141 FERC ¶ 61,236
UNITED STATES OF AMERICA
FEDERAL ENERGY REGULATORY COMMISSION

[Docket Nos. RM12-6-000 and RM12-7-000; Order No. 773]

Revisions to Electric Reliability Organization Definition of Bulk Electric System and
Rules of Procedure

ORDER NO. 773

Figure 1
Two Radial Systems Eligible for Exclusion E1

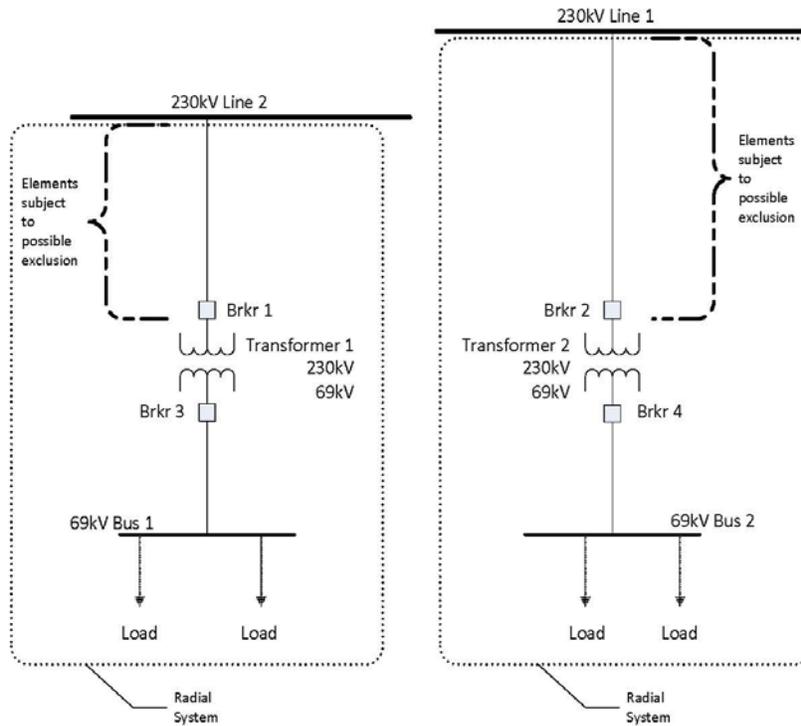
135. NERC and other commenters state that both radial systems depicted in figure 1 would be subject to exclusion E1(a) because they each only serve load.¹²⁶ ELCON agrees with NERC adding that these types of radial systems pose no reliability risk to the interconnected transmission network if the system is lost due to a fault condition.

Similarly, SoCal Edison states that the figure 1 facilities would either be excluded or not

part of the bulk electric system. SoCal Edison asserts that, because transformers 1 and 2 each have secondary voltages that are less than 100 kV, they do not meet the inclusion II requirements and, thus, are not included in the bulk electric system. In other words, SoCal Edison believes exclusion E1 should exclude all radial facilities that are greater than 100 kV up to the point where “the system is no longer radial, as indicated in figure 1 by the brackets where the 230 kV lines meet [lines 1 and 2].”¹²⁷ APPA believes that all the scenarios described by the Commission could create reliability concerns “if taken in isolation and operated in a certain matter” and believes that the exception process can capture configurations that pose a significant risk to the reliable operation of the interconnected transmission network. Idaho Power maintains that it is inappropriate to apply exclusion E1 for 230 kV elements in the scenarios if the breakers are part of the protection scheme for a three terminal 230 kV line. Idaho Power adds that if either breaker only opens for transformer protection, the exclusion would be applicable.

136. Anaheim agrees that the radials shown in figure 1 should be excluded and requests clarification that the associated bus work and protection system equipment installed on those radial lines are also excluded. Anaheim advocates that the exclusion should also apply to protection system equipment on the excluded facilities that provide backup protection for devices that are part of the bulk electric system, i.e. lines 1 and 2 in figure 1.

140. The Commission agrees with NERC that the radial systems shown in figure 1 meet the definition of “radial system” in exclusion E1. This configuration would result in the 230 kV lines between transformers 1 and 2 to the two 230 kV lines, respectfully, being excluded from the bulk electric system. The Commission agrees with NERC and other commenters that both radial systems depicted in figure 1 would be subject to exclusion E1 condition (a) because they each only serve load.

Figure 2
Networked Configuration w/115 kV Loop

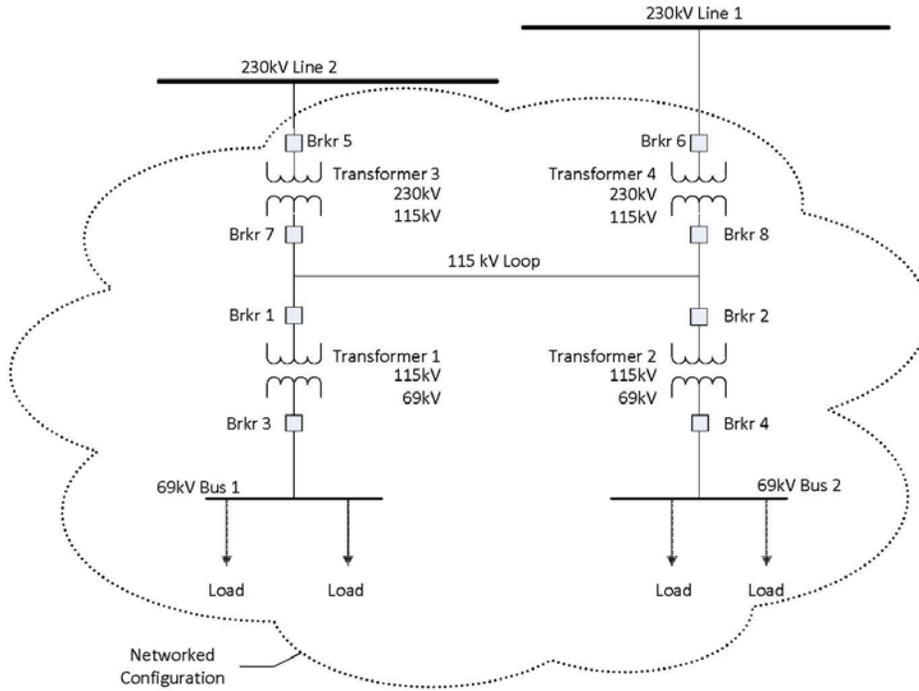
144. In the NOPR, the Commission requested comment on the scenario shown in figure 2 which shows a 115 kV loop, with the configuration emanating from two points of connection of 100 kV or higher. Specifically, the Commission requested comment on whether “the 115 kV and 230 kV elements above Transformers 1 and 2 to the points of connection to the two 230 kV lines would be excluded from the bulk electric system pursuant to exclusion E1.”¹³⁰ The Commission asked for comment on whether it is more appropriate to analyze figure 2 pursuant to the “local network” exclusion E3 and, if so, what if any elements operated at or above 100 kV would be excluded pursuant to exclusion E3.

145. NERC states that figure 2 is a non-radial loop on the 115 kV system. According to NERC, the 115 kV elements above transformers 1 and 2 to the point of interconnection with lines 1 and 2 would not be eligible for exclusion E1 because they do not emanate from a single point of connection. NERC also states that it would be appropriate to evaluate figure 2 under exclusion E3 as a potential local network.¹³¹ For such a

146. Likewise, Idaho Power, ITC Companies, and National Grid contend that the figure 2 configuration should be included in the bulk electric system. Southern Companies believe exclusion E1 may apply from the breakers down and that the configuration may belong to exclusion E3. AEP assumes that each of the facilities below the 115 kV loop shown in figure 2, and including breaker 1 and breaker 2, are radial and excluded pursuant to exclusion E1. According to AEP, the facilities above breakers 1 and 2 may be excluded pursuant to exclusion E3 depending on the circumstances.¹³³

147. Valero states that the figure 2 configuration is very similar to common facilities configurations employed in many industrial facilities involving the interconnection of the industrial facility to the utility through two high voltage feeder lines that originate at different utility owned and operated substations. Valero requests that the Commission include in the final rule an additional exclusion that would “categorically exclude from the [bulk electric system] any on-site high voltage switchyard facilities (less than 300 kV) owned by the industrial end-user where the predominant function of the facilities is to

distribute electricity in an inward direction to the end-user's load.”¹³⁴ WPPC argues that figure 2 shows both radial and network systems and that the system from the 115 kV loop upwards would be assessed under exclusion E3 and below that point would be assessed by exclusion E1.

148. The Commission affirms NERC's statement that figure 2 is a non-radial loop and thus would not be eligible for exclusion E1 because it does not emanate from a single point of connection. The Commission agrees with commenters that the elements below the 115 kV loop should be assessed as two separate radial systems pursuant to exclusion E1. The remaining elements (the 115 kV loop, transformers 3 and 4 and the 230 kV tie lines above the transformers to the two 230 lines 1 and 2) should be assessed pursuant to exclusion E3 and if the configuration meets the criteria of exclusion E3, the elements could be excluded.

Figure 3
Networked Configuration w/69 kV Loop

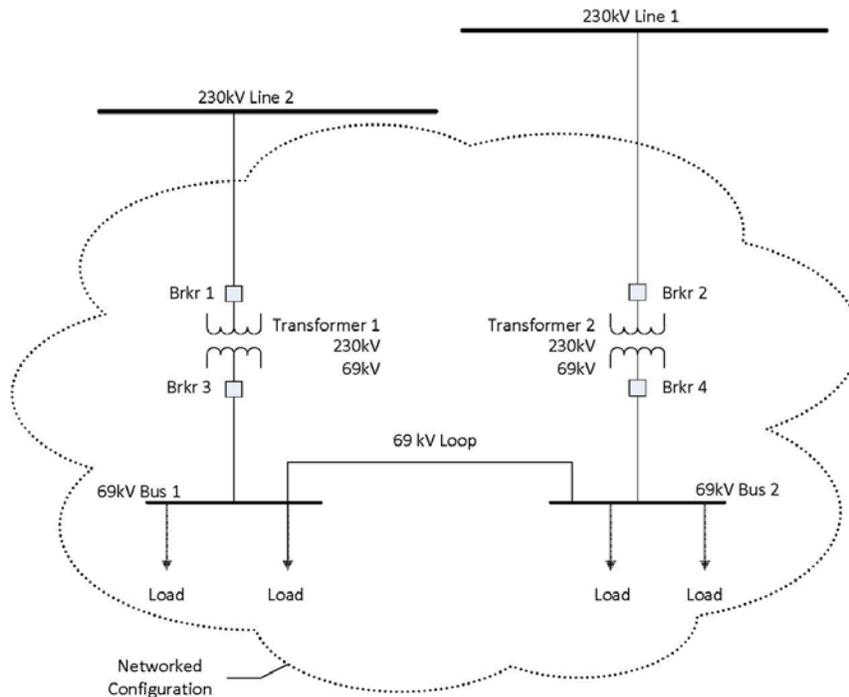
151. NERC disagrees with the Commission's characterization of figure 3 in the NOPR. NERC states that figure 3 does not depict a configuration with two points of 100 kV or higher or a system emanating from two points of connection at 230 kV. According to NERC, except for lines 1 and 2, all the other elements depicted in figure 3 are excluded from the bulk electric system. NERC explains that the elements between line 1 and transformer 2 and from line 2 to transformer 1 are excluded by exclusion E1(a) because "each separate set of [e]lements [described above] is contiguous and emanate from a

153. Exelon agrees with NERC and explains that it has many connections similar to the one shown in figure 3 and provides a specific example where a 138 kV substation is fed by two radially connected 138 kV lines which in turn are connected through 40 MVA transformers to a 12 kV bus section. Exelon states that in its example the 40 MVA transformers cross bus sections so that if one of the 138 kV lines is out of service, each side of the 12 kV bus retains service. Exelon believes that due to the high impedance of the transformers, little energy flows between the buses in Exelon’s example.¹³⁸ Exelon

154. Other commenters believe that the figure 3 configuration may not be eligible for exclusion E1. SoCal Edison explains that the 69 kV loop is not open and therefore is a parallel path to the 230 kV system. BPA, Alameda and WREA do not view the figure 3 system as eligible for exclusion E1 because the system is networked. Idaho Power states that the 230 kV lines would be included only if there is a protection system in place for the 230 kV lines. According to Idaho Power, the elements above the transformers in figure 3 would not be excluded from the bulk electric system. Idaho Power believes this configuration should be evaluated under exclusion E3.

155. The Commission finds figure 3, which is identical to figure 5, is a networked configuration through a 69 kV loop and does not qualify for exclusion E1. The Commission also finds that, because the load in figure 3 can be served by either 230 kV line, it does not depict a “radial system.” However, the facilities below 100 kV may or may not be necessary for the operation of the interconnected transmission network, and this decision can be made case-by-case in the exception process. In other words, such facilities below 100 kV depicted in figure 3 would be excluded under the general threshold of the core definition unless found on a case-specific basis as necessary for the reliable operation of the interconnected transmission network. Thus, the Commission, while disagreeing with NERC’s interpretation, does not propose to include the below 100 kV elements in figure 3 in the bulk electric system, unless determined otherwise in

the exception process. Further, as we discuss below in connection with exclusion E3 and figure 5, while we find that the configuration shown in figures 3 and 5 would not be eligible for exclusion E1, we believe that such configurations should be eligible for exclusion E3 for local networks. However, exclusion E3 as written requires the candidate local network to be contiguous and above 100 kV, thus, the exclusion E3 language as written does not allow for figures 3 and 5 to be eligible for the local network exclusion because they are not contiguous *and* include facilities that are not above 100 kV. Therefore, we direct NERC to modify exclusion E3 to remove the 100 kV minimum operating voltage in the local network definition. This modification will enable configurations similar to figures 3 and 5 to be assessed for the local network exclusion. The Commission believes this modification, together with satisfying the criteria outlined in exclusion E3, will appropriately exclude local network configurations that are not necessary to the reliable operation of the interconnected transmission network.¹³⁹

Figure 5
Networked Configuration w/69 kV Loop

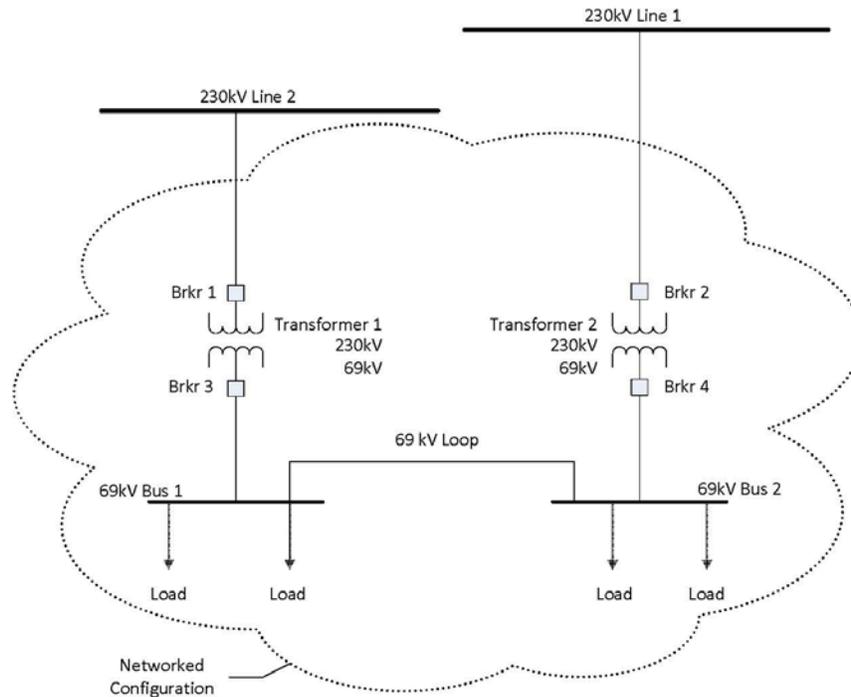
195. In the NOPR, the Commission stated that figure 5 depicts a group of elements that are contiguous through a 69 kV loop and requested comment whether the configuration in figure 5 qualifies as a local network and, in particular, whether the configuration satisfies the conditions that a local network be contiguous and operated at or above 100 kV.

196. NERC views figure 5 the same as figure 3 - as a looped system below 100 kV - that is not considered under this exclusion because the elements below 100 kV are

presumed to be not part of the bulk electric system.¹⁶⁷ NERC maintains that, if it is determined that the sub-100 kV looped system is necessary for the reliable operation of the interconnected transmission network, the exception process may be utilized to include the appropriate elements. NERC states that figure 5 depicts two separate and distinct groups of elements that each emanate from a single point of interconnection at 230 kV and only serve load. Accordingly, NERC states that 230 kV lines 1 and 2 are included in the bulk electric system with the only other included elements being the lines extending from lines 1 and 2. However, according to NERC, the elements between 230 kV line 1 and transformer 2 and between 230 kV line 2 and transformer 1 are each subject to exclusion E1(a) because each separate set of elements is contiguous and emanate from a single point of connection of 100 kV or higher. NERC asserts that the elements below the 69 kV side of transformers 1 and 2 are excluded because they are less than 100 kV. NERC explains that transformers 1 and 2 are excluded because they bridge voltages of 69 kV and 230 kV and therefore, inclusion I1 is not applicable because a transformer must have two terminals over 100 kV to qualify for inclusion I1. According to NERC, the definition should focus on looped or networked connections at 100 kV or greater because such connections, when operated below 100 kV, generally do not carry

197. Exelon states that the clear intent of the definition is that configurations such as shown in figure 5 are radial systems subject to exclusion E1 (radial systems). According to Exelon, had this not been the intent of exclusion E1, exclusion E3 would have allowed for a local network where the tie was below 100 kV to avoid a reliability gap. Exelon believes that the configuration shown in figure 5, which is identical to figure 3, does not qualify as a local network within the terms of exclusion E3 and supports NERC's view that figure 5 represents two radial systems that qualify under exclusion E1. Exelon cautions that, if the Commission determines that the systems depicted in figure 5 do not qualify under exclusion E1 because of the low voltage tie and does not qualify under exclusion E3 because the tie is at low voltage and not a 100 kV or above, such a decision would leave a gap under which a substantial number of facilities that are not part of the bulk electric system would be classified as such. Exelon states that it would have to go through the separate exception process for dozens of substations, at great cost and for no useful purpose. Exelon states that the Commission should clarify that the configuration shown in figures 3 and 5 qualifies as a radial system and is excluded pursuant to exclusion E1.

199. As discussed above, the Commission is directing a modification to exclusion E3 to better capture local networks like those depicted in figure 5. The Commission notes that Exelon believes that the configuration shown in figure 5, which is identical to figure 3, does not qualify as a local network within the terms of exclusion E3. While figures 3 and 5 are a networked configuration through a 69 kV loop, they do not qualify for the local network exclusion because exclusion E3 defines local networks as “[a] group of contiguous transmission Elements operated at or above 100 kV but less than 300 kV that distribute power to Load rather than transfer bulk-power across the interconnected system.” The configuration in figure 5 includes elements that are below 100 kV, and does not have contiguous elements operating at or above 100 kV but less than 300 kV. As noted above, while the Commission finds that these configurations should not be eligible for exclusion E1, we believe that they should be eligible for the local network exclusion. Therefore, we direct NERC to modify exclusion E3 to remove the 100 kV minimum operating voltage in the local network definition. Within 30 days of the effective date of this Final Rule, we direct NERC to submit a schedule outlining how and when it will make the modification to the definition.
